SR 520 'Rest of the West'

Meeting Summary

April 7, 2016

Concept Design

Figure 2: Proposed lighting elements

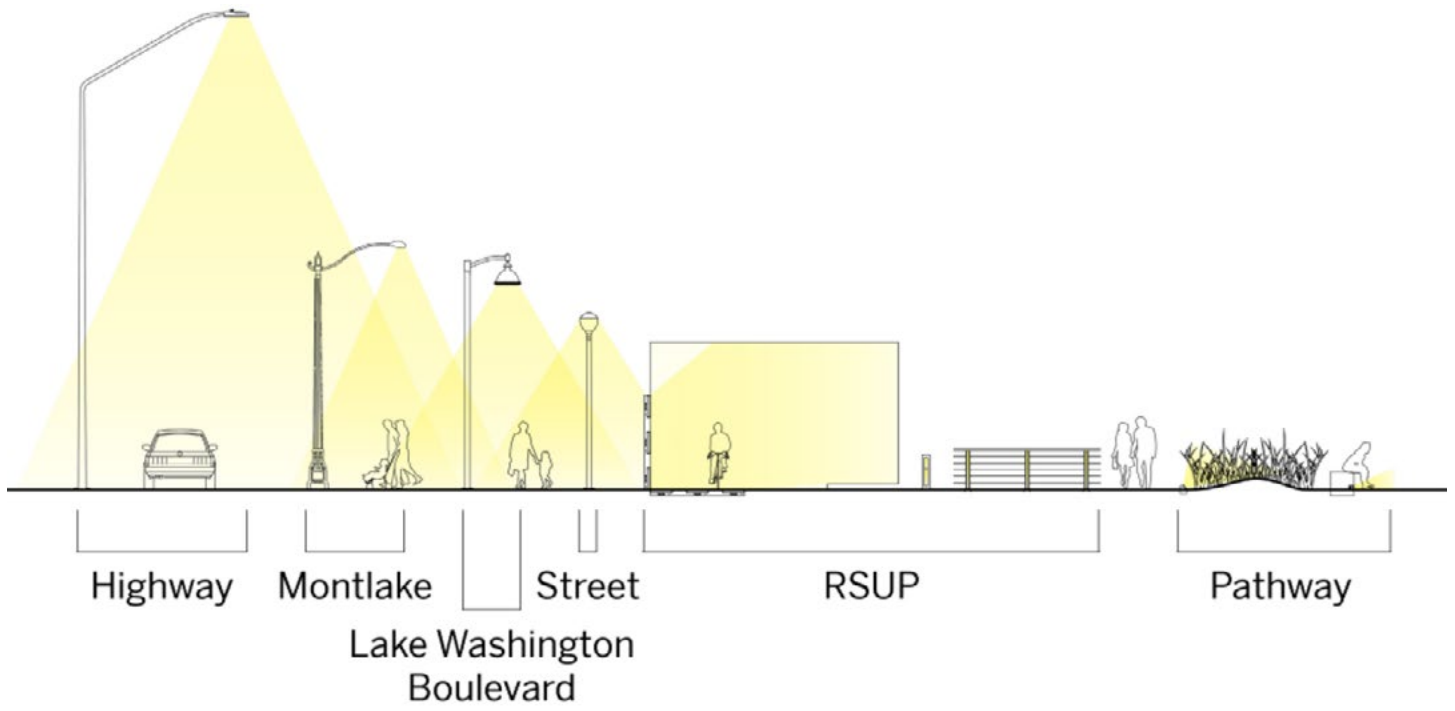
1. The integration of the landbridge with the surrounding corridor
2. The continuity of lighting types in the lid and pedestrian routes
3. How terraced landscaping is used to reduce vehicle noise
4. Continued ways to combine landscaping with concrete walls that soften those features and support plant growth

The SDC expressed agreement with design elements such as using terraced landscaping as a way to reduce vehicular acoustics, creating a garden experience along the land bridge, providing continuity in lighting types, and providing a tactile experience by combining the natural landscape with walls throughout the corridor.

Figure 4: Previous landbridge design (top) and updated landbridge design (bottom)

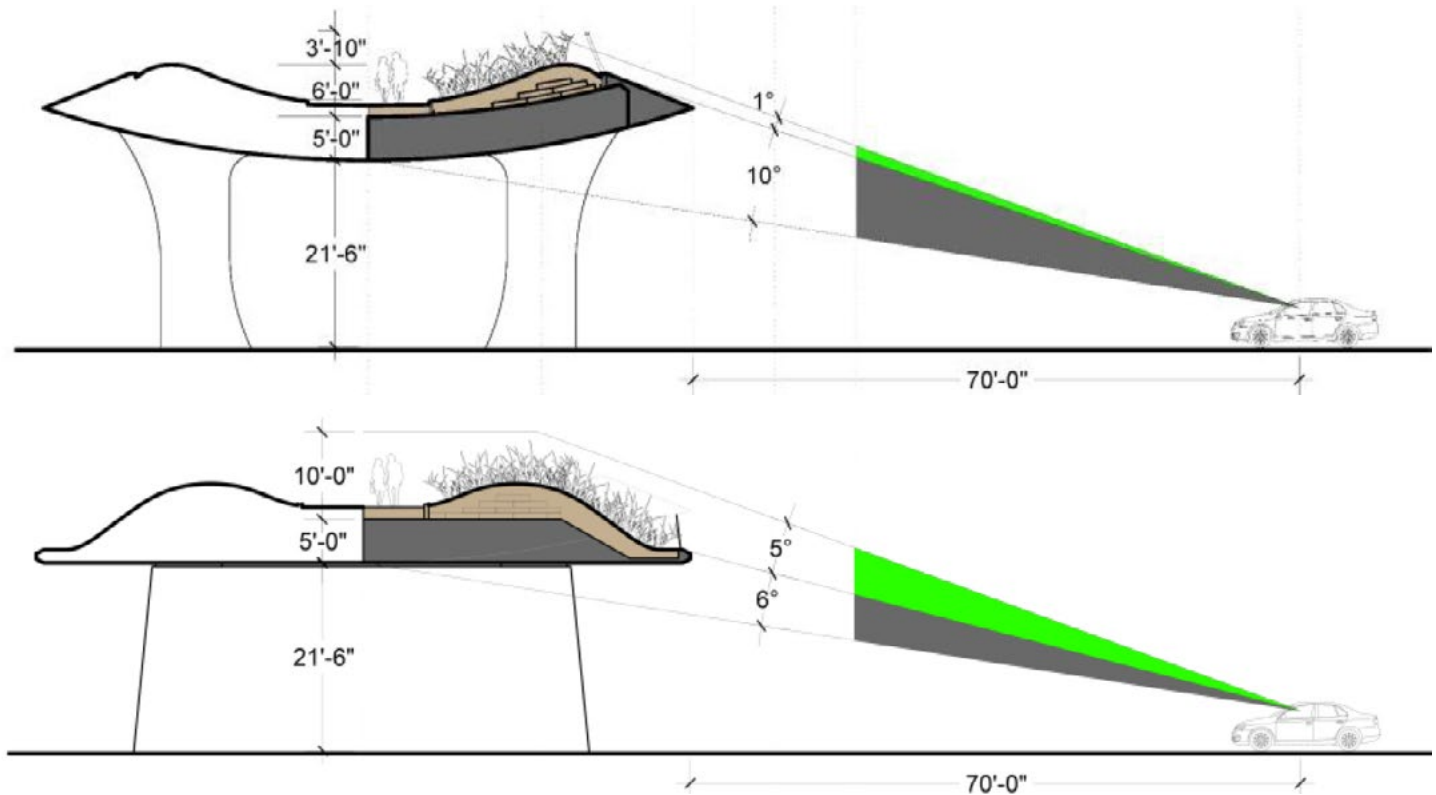
since the previous meeting. The original "saucer shaped" design provided limited views of the landscaping from the highway. The proposed design reversed the saucer design, allowing landscaping to blend into the edge of the landbridge while providing greater views from the highway. See figures 4 and 5 for more detail.
